**URGENT FIELD SAFETY NOTICE**

**Dialog<sup>+</sup> SW 9.xx Two Pump Machines (incl. HDF online)  
in which level regulation spare parts were exchanged**

**R-2014-002**

**Assembly and Detailed Testing Instruction**

Fig.: Correct connection **A**Fig.: Incorrect connection **B****3. Service Activities**

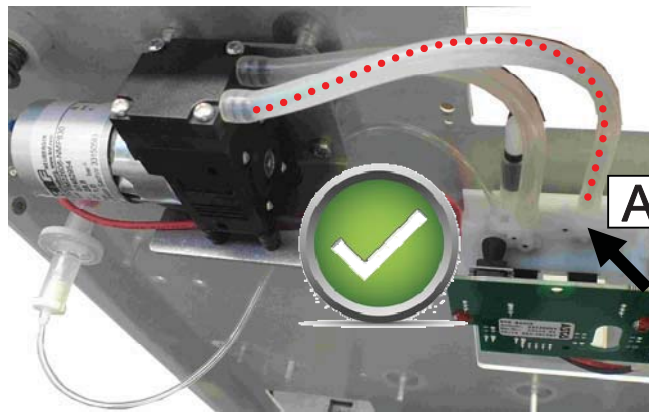
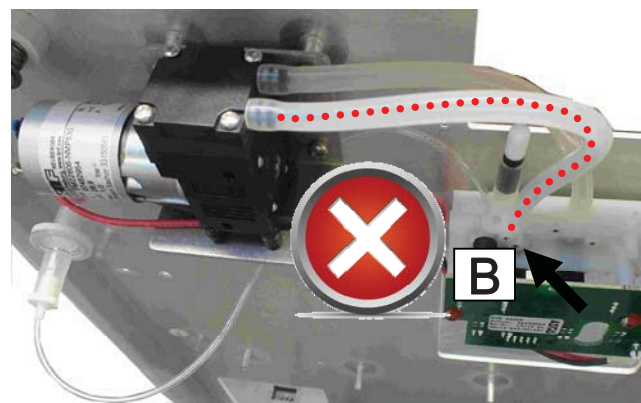
It is technically possible to connect the two tubes between the diaphragm pump and the valve block level regulation wrongly during a service activity when the diaphragm pump or when the valve block level regulation is replaced, i.e. the tubing can be inverted **B** at the pump or at the valve block. This inverted connection **B** will cause a malfunction of the level regulation system during the required functional check. Only in a single-needle cross-over treatment the intended increasing of the level of the arterial cross-over chamber can actually lead to an air infusion into the patient through the arterial patient connection.

The correct connection of the tubing **A** shall be ensured after assembly by a visual check, as well as a functional check by increasing and decreasing the levels inside the chambers using the *Up* and *Down* icons in a simulated treatment. The machine shall be released for patient use only if the level regulation works correctly, i.e. the level decreases when the *Down* icon is activated and the level increases when the *Up* icon is activated. This check shall be performed for all chambers of the connected tubing system to ensure the correct function of the option.

- Prepare the machine for a simulated treatment.
- Activate the *Up* and *Down* icons for each chamber.
- Confirm that the levels in the respective chambers actually increase and decrease.
